SUBJECT: Central Illinois Regional Airport  
Bloomington, Illinois  
McLean County  
Illinois Project Number: BMI-5206  
AIP Project Number: 3-17-0006-TBD  
Contract No. BL073  
Item No. 06A, June 13, 2025 Letting  
Addendum A

## NOTICE TO PROSPECTIVE BIDDERS

REHABILITATE RUNWAY 11/29 &  
ASSOCIATED IMPROVEMENTS -  
PHASE 1

06/05/25 ADDENDUM A

CD106  
SHEET 21 OF 94

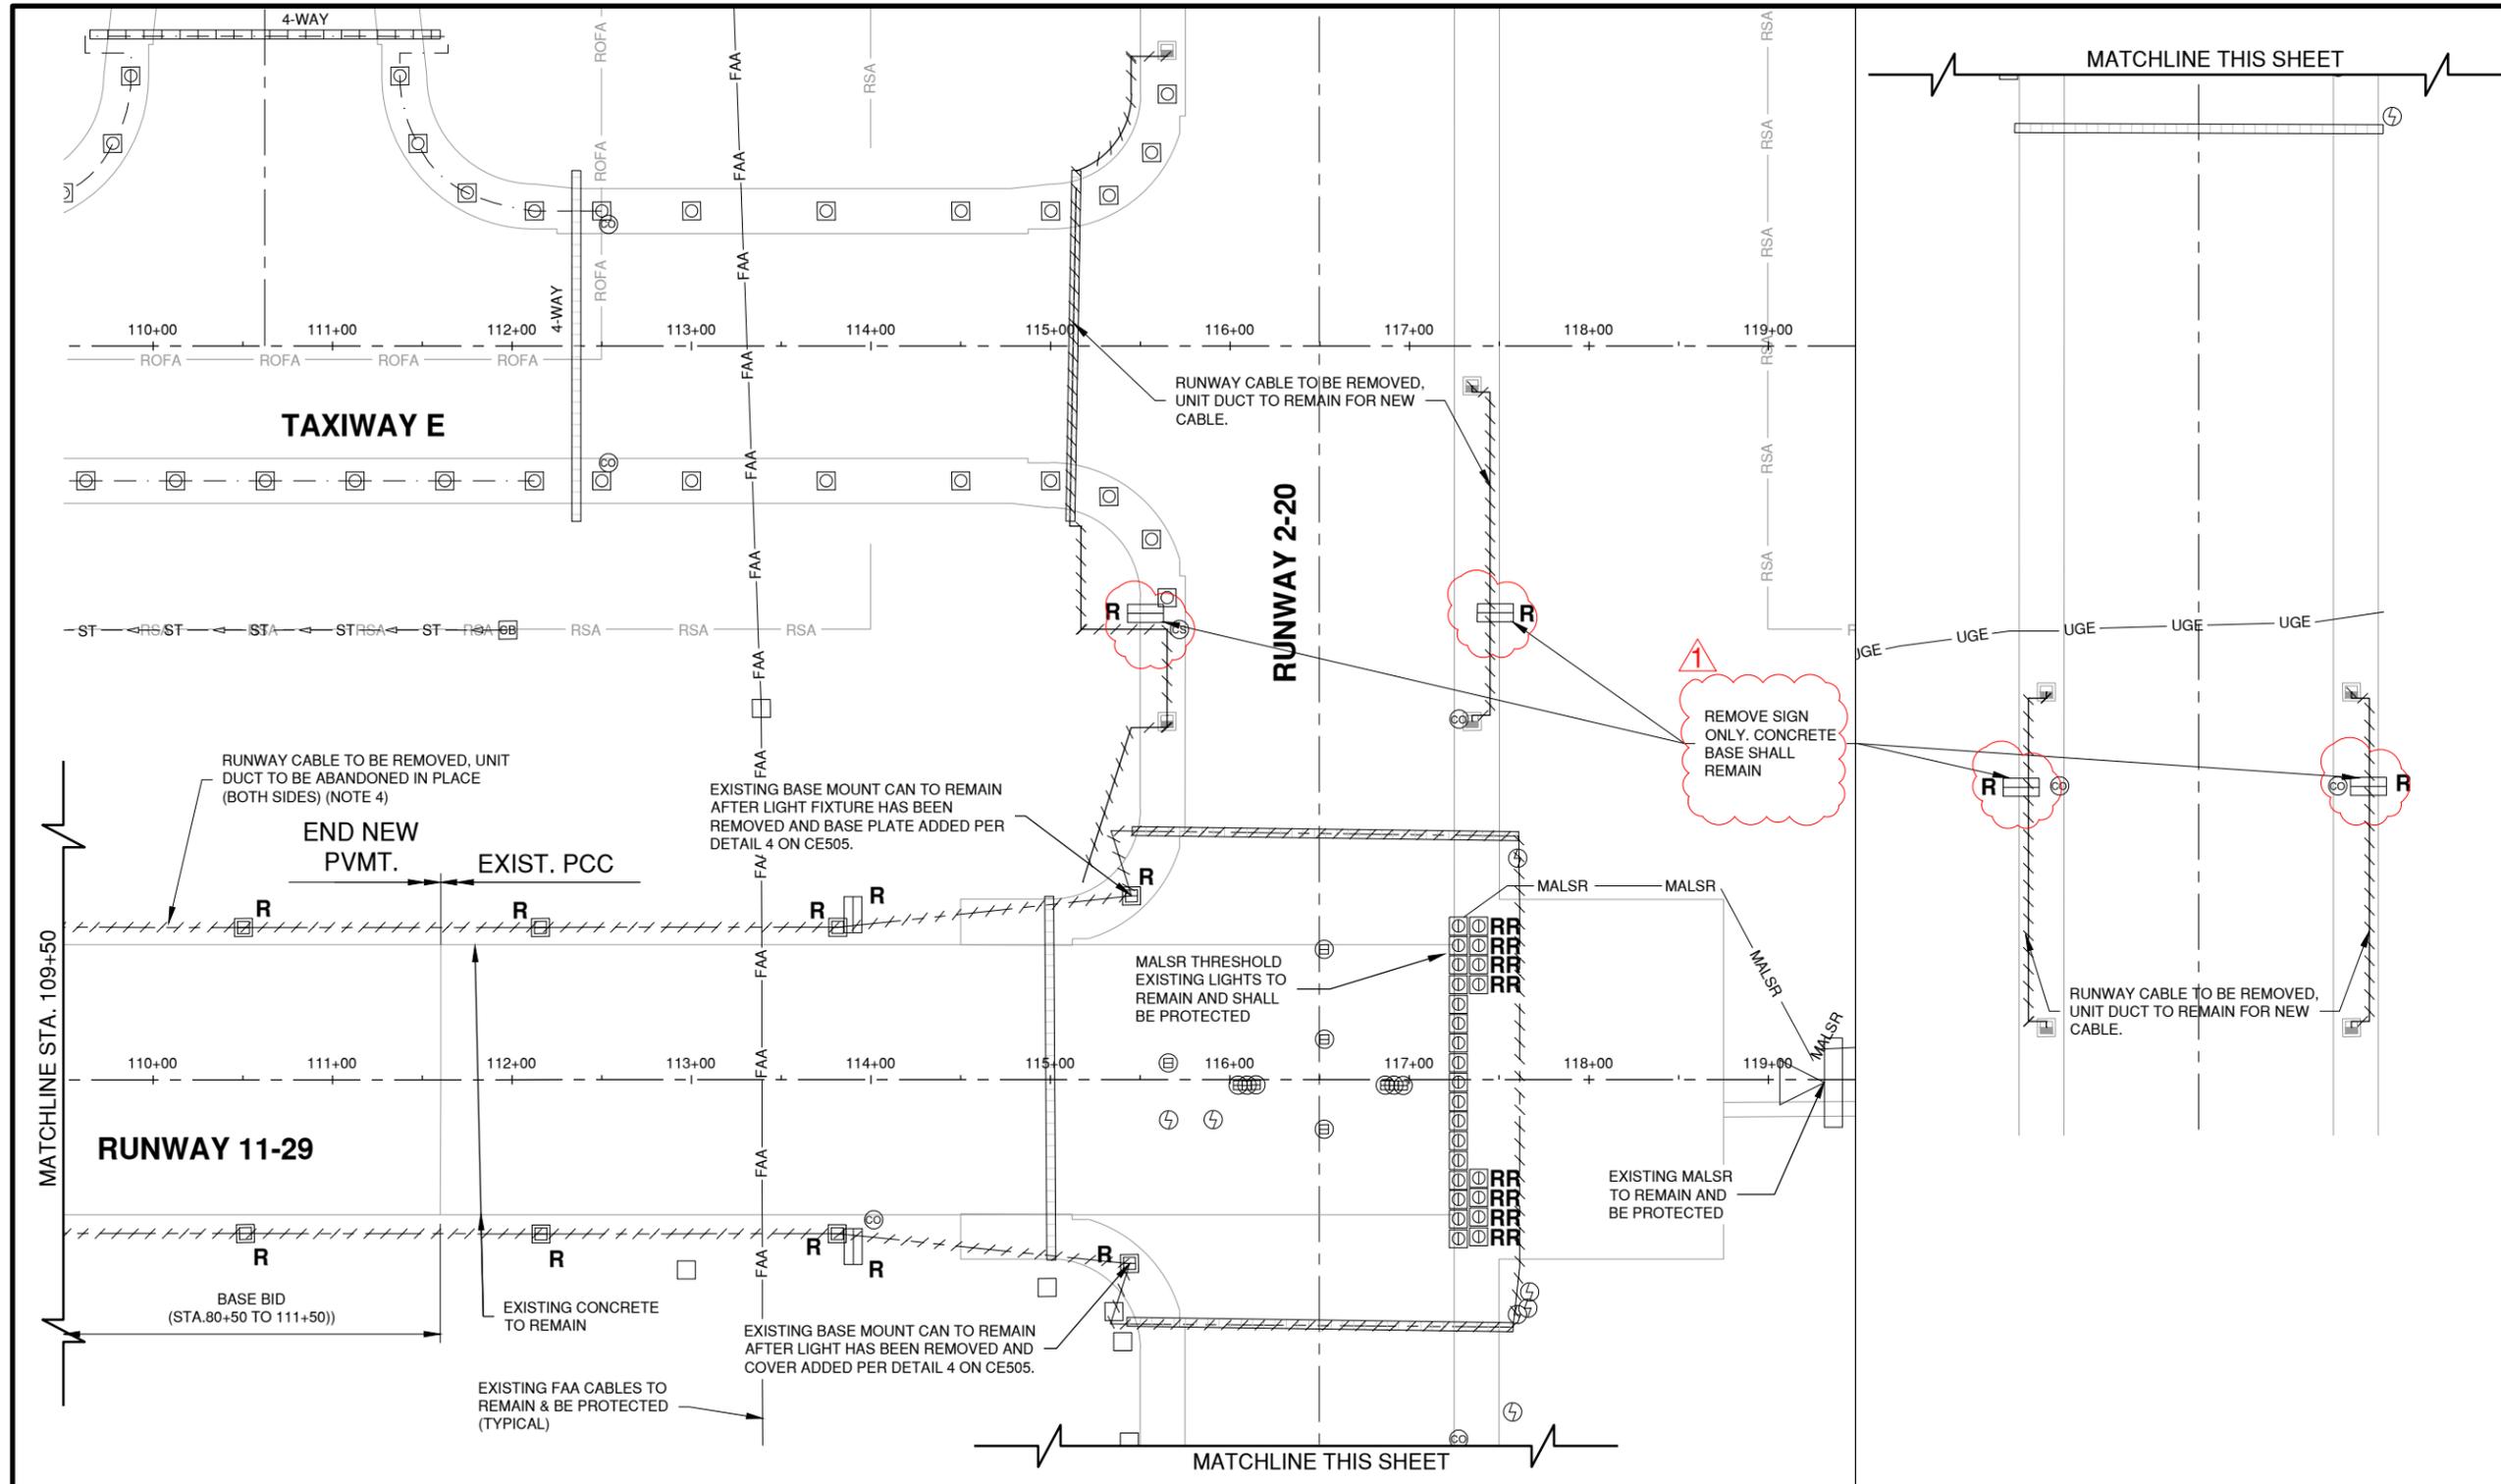
Sheet 21

REVISE to allow concrete sign base to remain in-place after sign removal.

**1 ADJUST UNDERDRAIN CLEANOUT**  
N.T.S

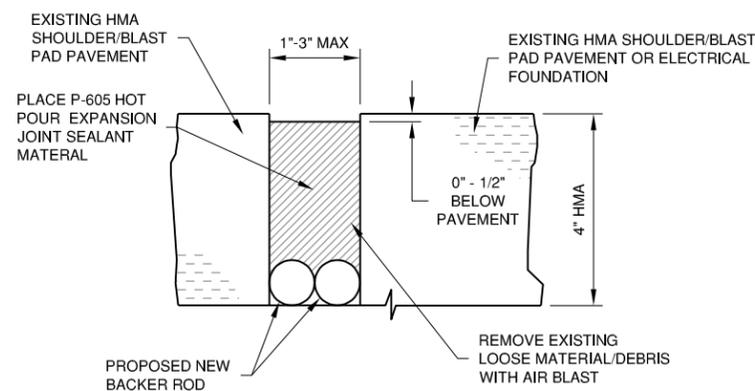
Sheet 35

ADD new detail for Adjust Underdrain Cleanout item.

**LIGHTING AND SIGN PLAN 1**

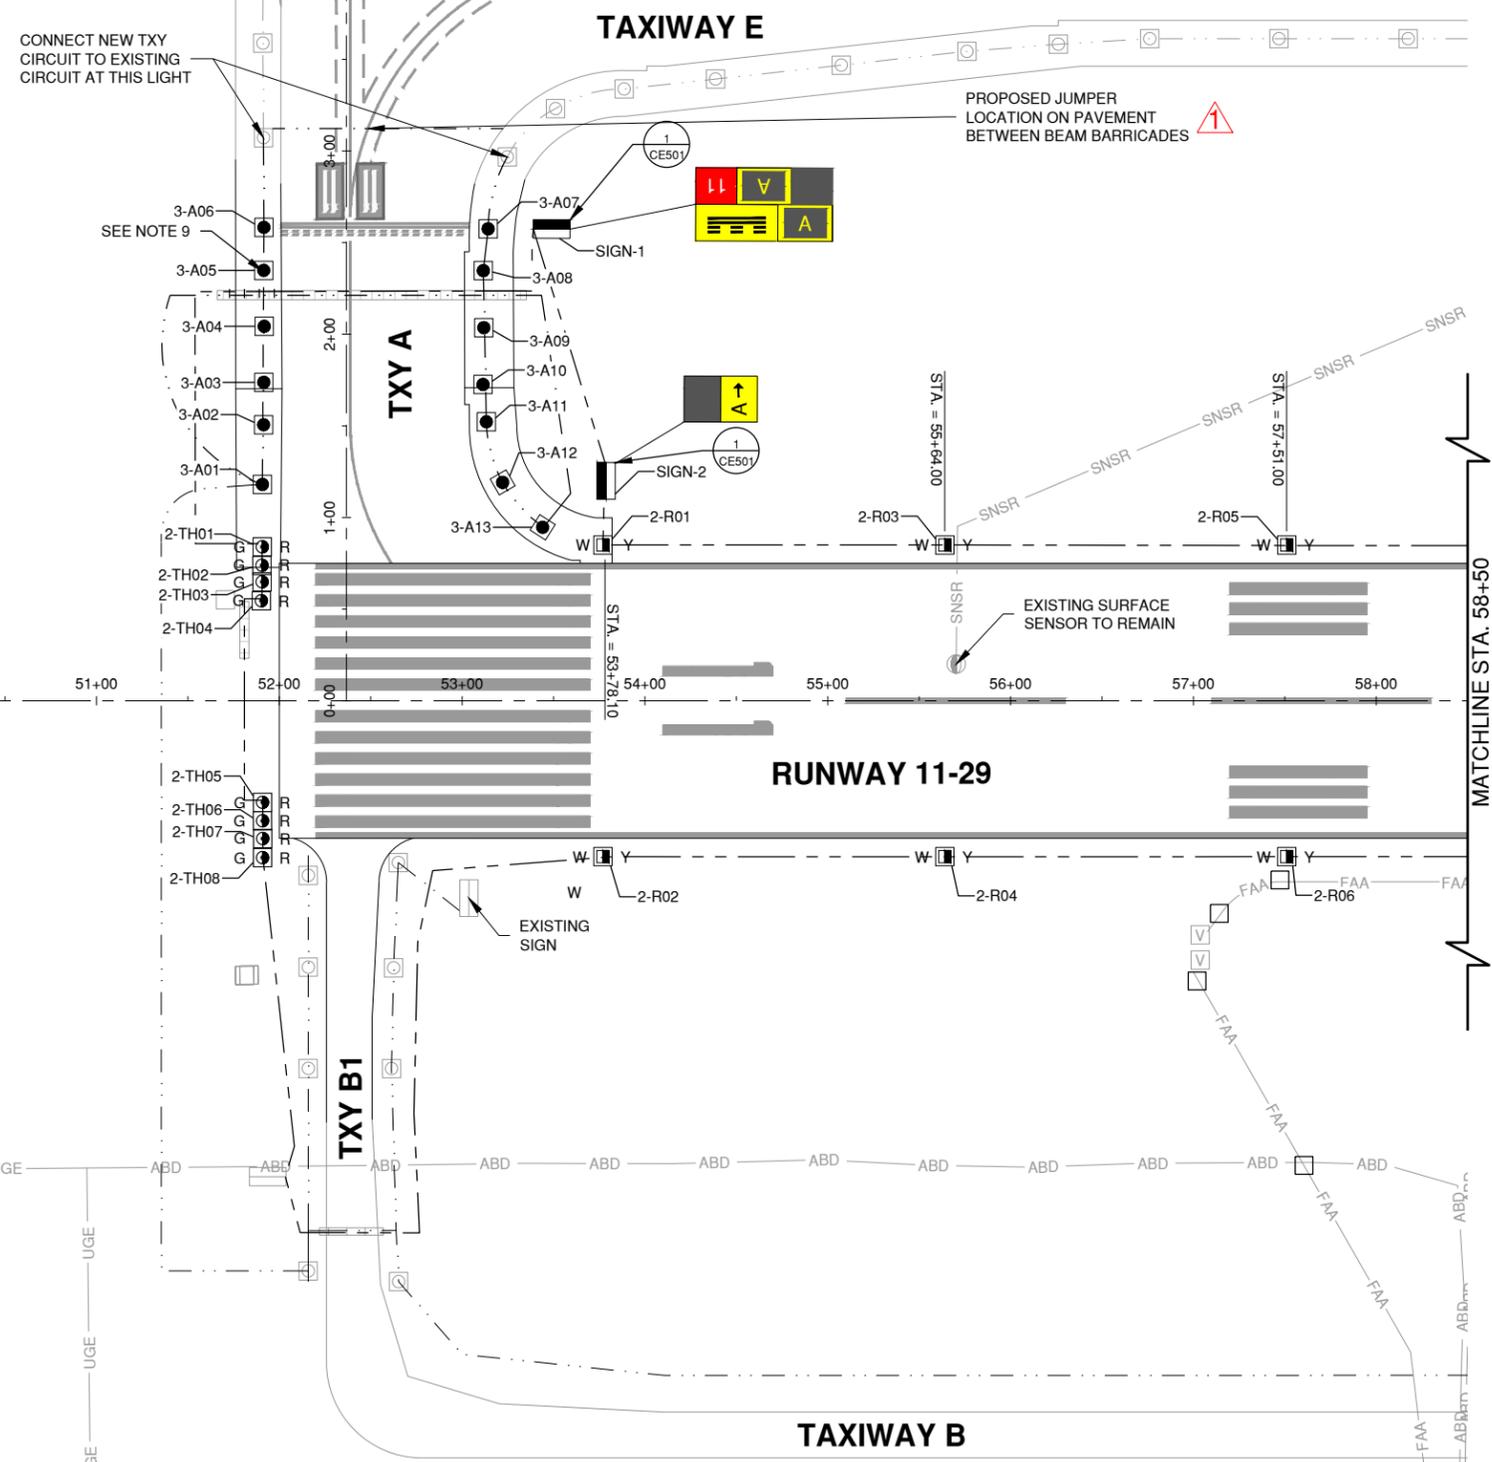
Sheets 45, 46, 49

REVISE to show proposed jumper cable locations.

CE108  
SHEET 52 OF 94

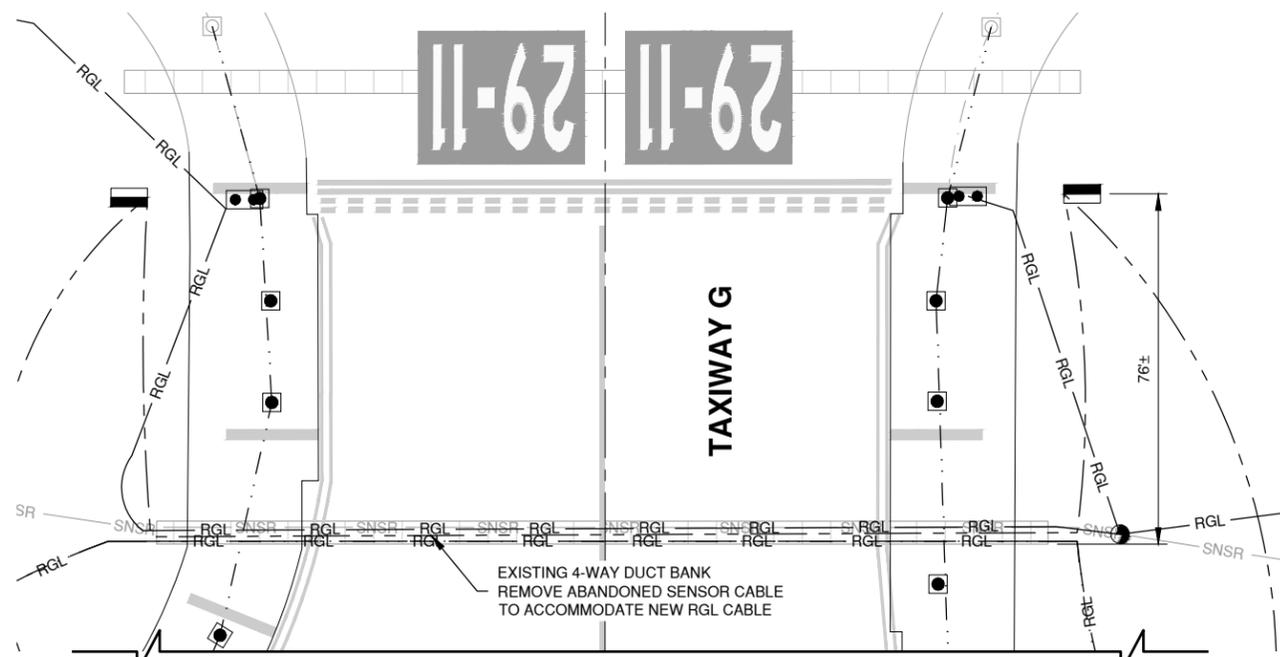
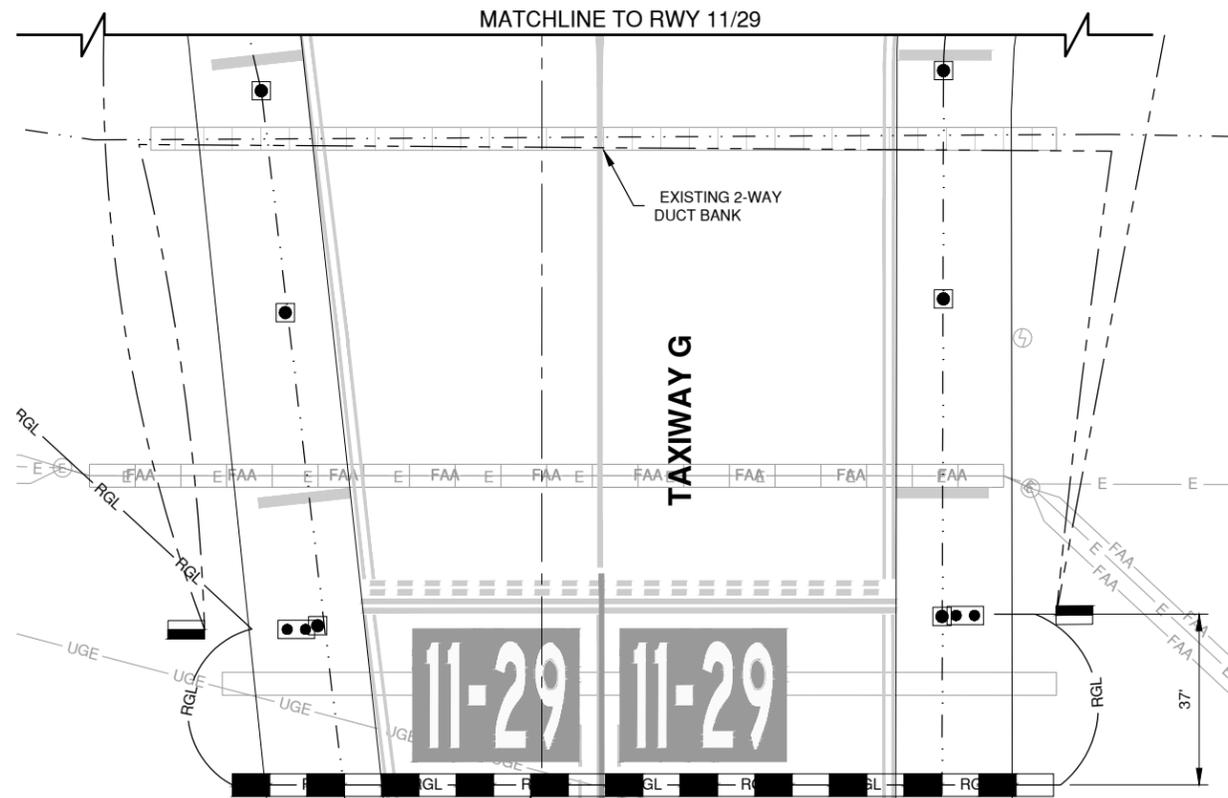
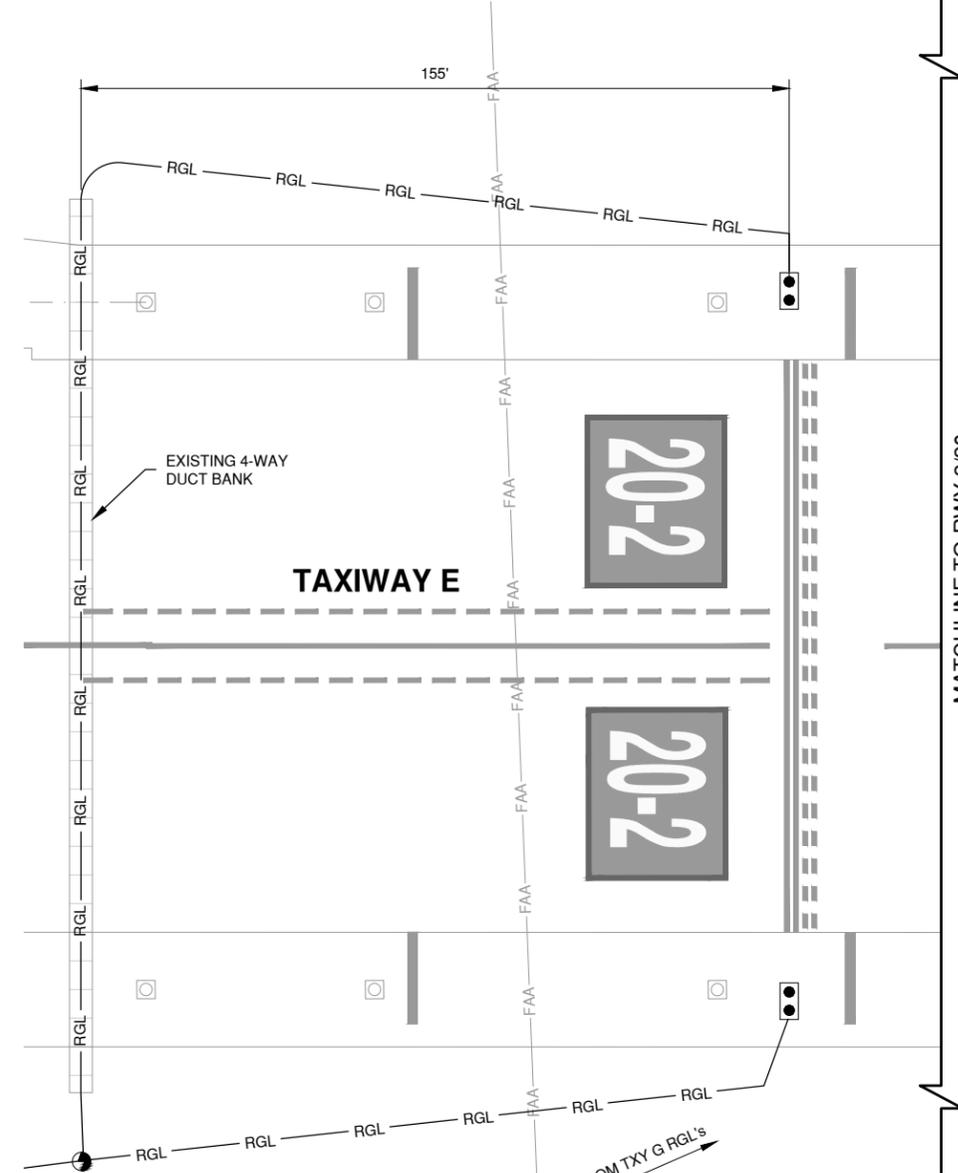
Sheet 52

REVISE Note 4.

4. SPLICE CANS MAY BE INSTALLED BY THE CONTRACTOR EVERY 500' ON THE ELEVATED GUARD LIGHT CIRCUITS TO PROVIDE PULL POINTS.
